Re: Consultation on Planning Application

Application Number: 200188

Address: 55 Vastern Road Reading RG1 8BU

Transport Comments

Figure 5.3: Station/River Major Opportunity Area Strategy

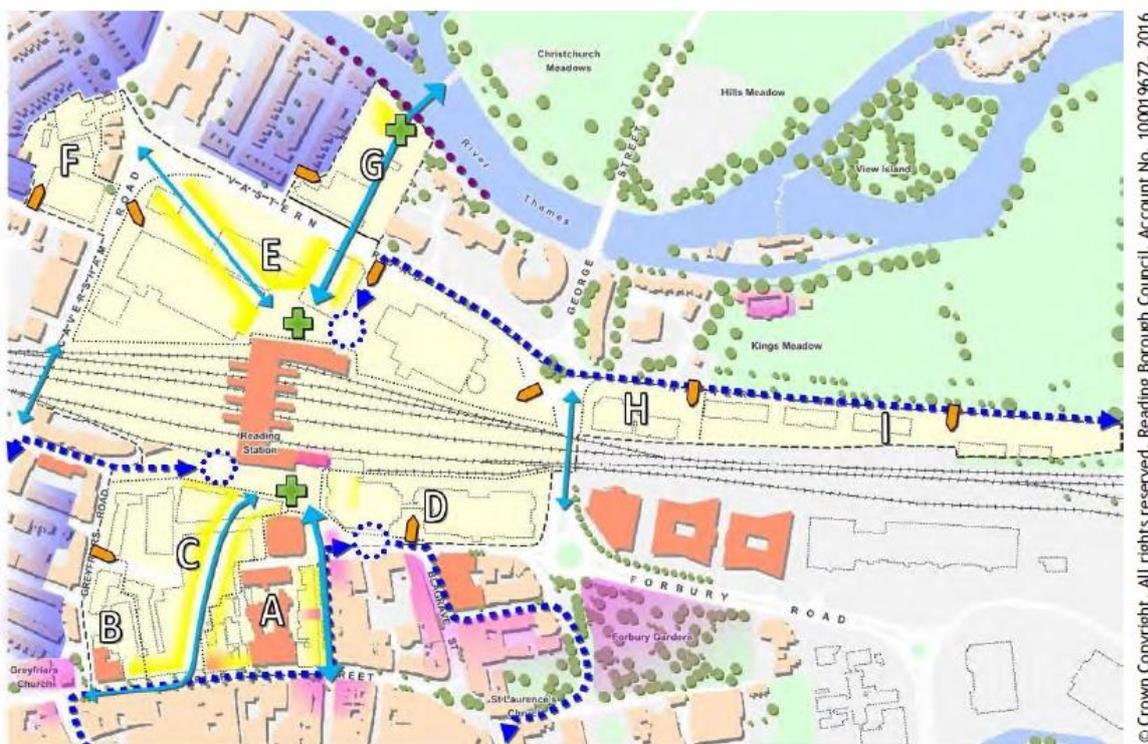
It is therefore clear from Figure 5.3 and Paragraph 5.4.6 from the Local Plan (both above) that an acceptable design of the north south route through the site is fundamental to any development of the site.

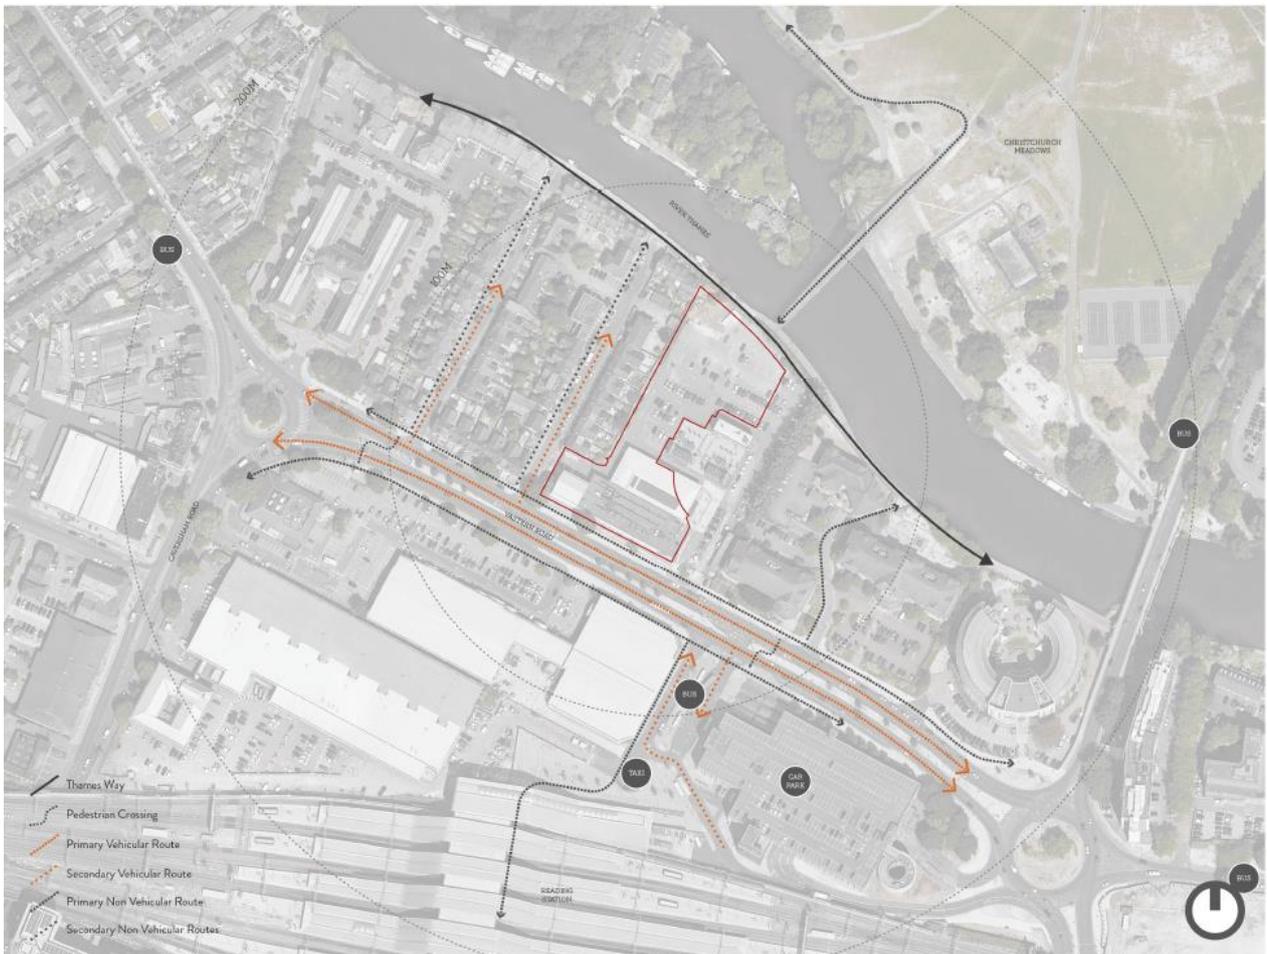
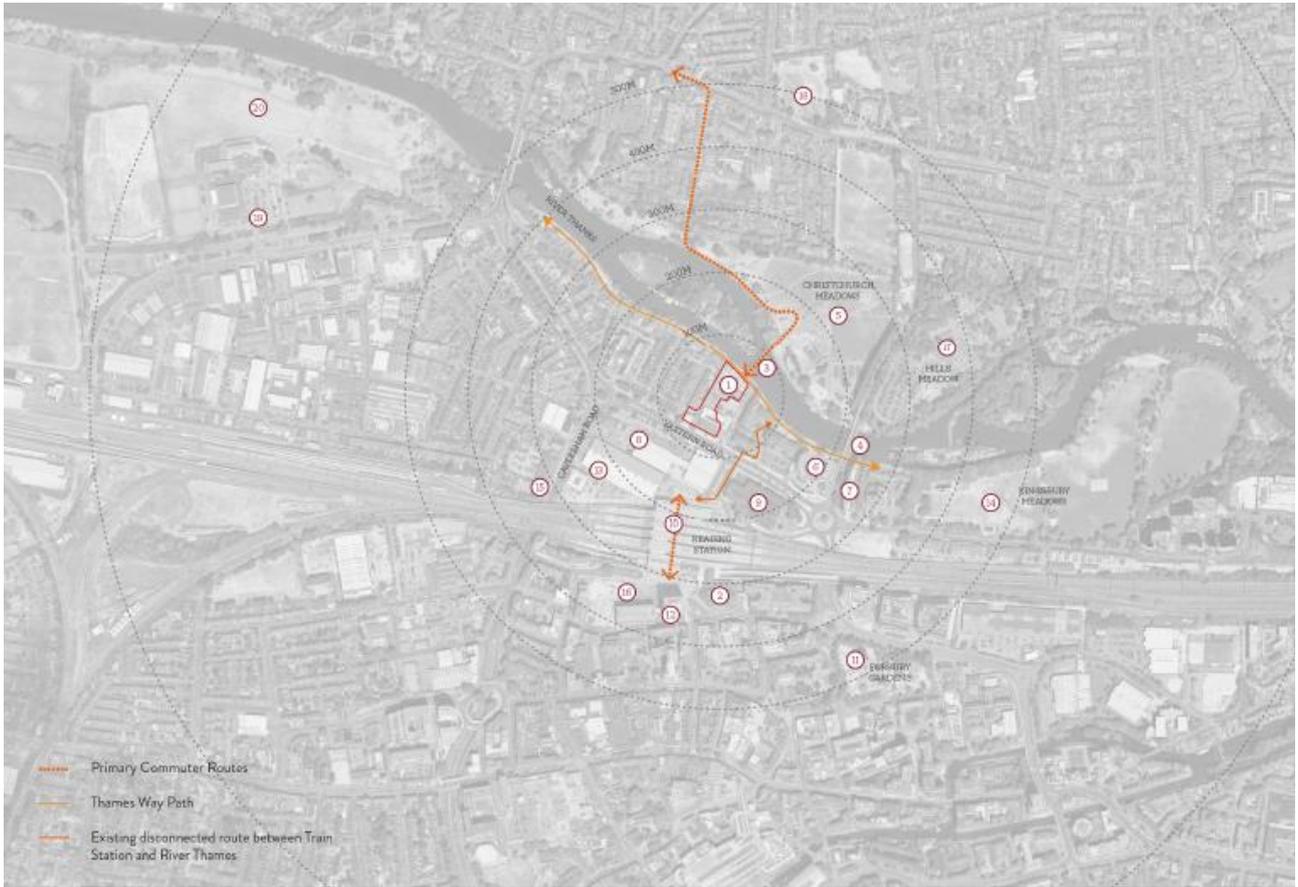
However, it is clear that the proposed scheme does not provide a direct pedestrian cycle route as has been requested during the pre-application discussions. This is to ensure that the route is as clear, legible and as convenient as possible. I reference the two images below from the Design and Access Statement which in themselves highlight the importance of the route through the site.

It was also stated during the whole pre-application process that should a direct route not be provided and a switch back design be included within the scheme that a technical justification would be required as to why this would not be provided. However, this has not been forthcoming within the submitted documentation.

The Highway Authority therefore does not agree with the proposed design of the footway / cycleway and this must be revised to remove the switch back and include a more direct route through the site.
